·	_		1(1) 31, 2010					
SUNDRY NOTICES AND REPORTS ON WELLS Do not use this form for proposals to drill or to re-enter an					5. Lesse Serial No. NMSF078463			
abandoned we	f	6. If Indian, Allettee or Tribe Name						
SUBMIT IN TRI		7. If Unit or CA/Agreement, Name and/or No.

PLUG AND ABANDONMENT PROCEDURE

Langendorf #1

Re: Permanent Abandonment

Proposed P&A

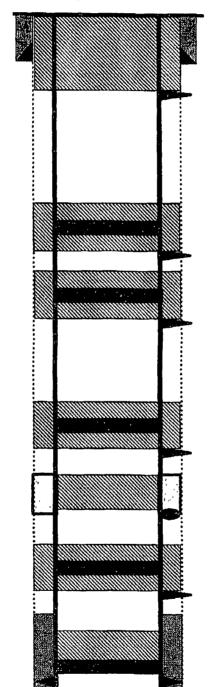
** BLM REVISED ** BLM REVISED ** BLM REVISED ** BLM REVISED **

245/7. 299(118) = 283 13 50/3.7559(1-18)= 11545 195/3.64 (48)= 46503 85 40

3459 3359

200/ 3.958 9 (1-18)= 435Ks

5550 5450

- 1. Plugging operations authorized are subject to the attached "General Requirements for Permanent Abandonment of Wells on Federal and Indian Lease."
- 2. Farmington Office is to be notified at least 24 hours before the plugging operations commence (505) 564-7750.
- 3. The following modifications to your plugging program are to be made:
- a) Place the Gallup plug from 5550' 5450' inside and outside the 5 ½" casing.
- b) Place the Mesaverde plug from 3459' 3359' inside and outside the 5 1/2" casing.

You are also required to place cement excesses per 4.2 and 4.4 of the attached General Requirements.
